SIB 61 16 20

SERVICE ACTION: REWORKING THE HIGH-VOLTAGE SYSTEM CONNECTOR

E-Series	Model Description
G20	330e Sedan

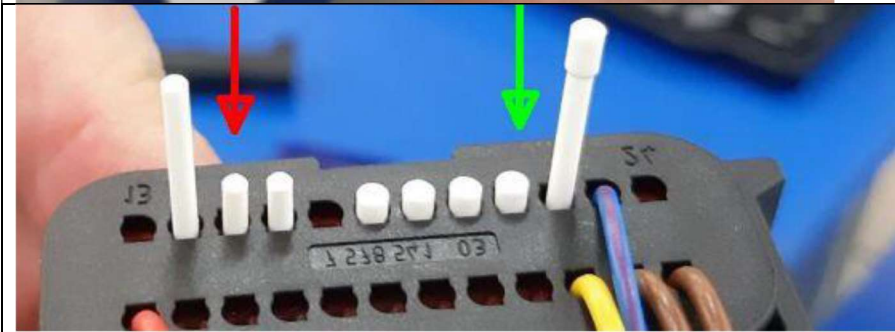
4. Replace all the white sealing plugs on connector A332*1B.

Pay attention to installation direction! The thinner end of the plug is installed first.

Green, OK

Red, Incorrect

5. Mount the cover cap using fabric adhesive tape.
